**Heckington Fen Wind Park
Heckington Fen, near East Heckington**

Application to vary S. 36 consent and deemed permission

**RESPONSE STATEMENT OF
DR MATTHEW CAND
TO THE APPRAISAL REPORT OF
DR JOHN YELLAND
ON
NOISE**

Figure A – Example of elevated noise levels likely due to excavator activity (highlighted in red, shown in relation to ETSU-R-97 quiet day-time (yellow bar) and night-time (purple bar) periods. This shows that the noisy activity occurred during periods discarded under ETSU-R-97.

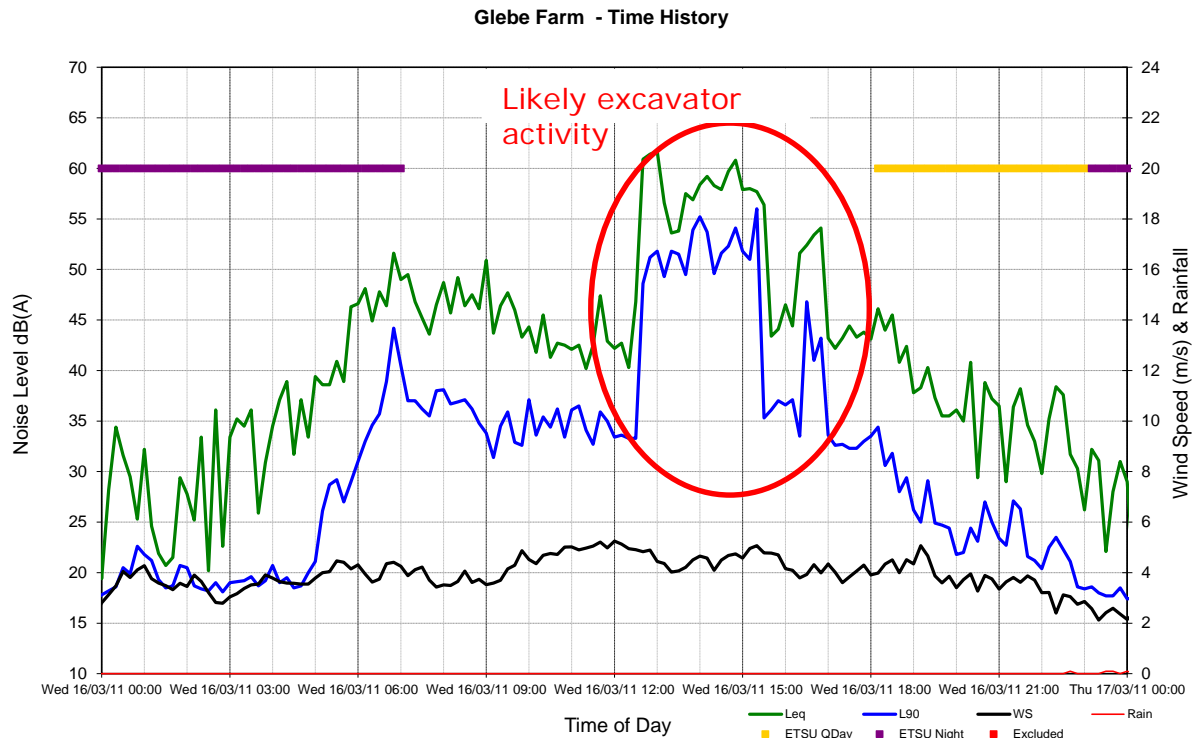
Finally, we are aware that the resident of Glebe Farm was carrying out earthworks with an excavator during the survey period, and this was observed during one of the site visits as taking place near to the caravan that is visible in Figure C17 of Appendix 10.C of the ES. Dr Yelland expresses concerns that this atypical data was not excluded from the survey. We would note that excavation works were only observed during daytime hours on weekdays, and are only apparent in the survey data during these times. Daytime periods (between 07:00 and 18:00) on weekdays are excluded from the “quiet day-time periods” under the ETSU-R-97 methodology, and therefore these periods were removed from the assessment without any need for further filtering of data. There is no suggestion from the measured data that excavation work was being carried out in the evening, during night-time or at weekends, so there was no need for further filtering of the data. An example of this is shown in Figure A below.
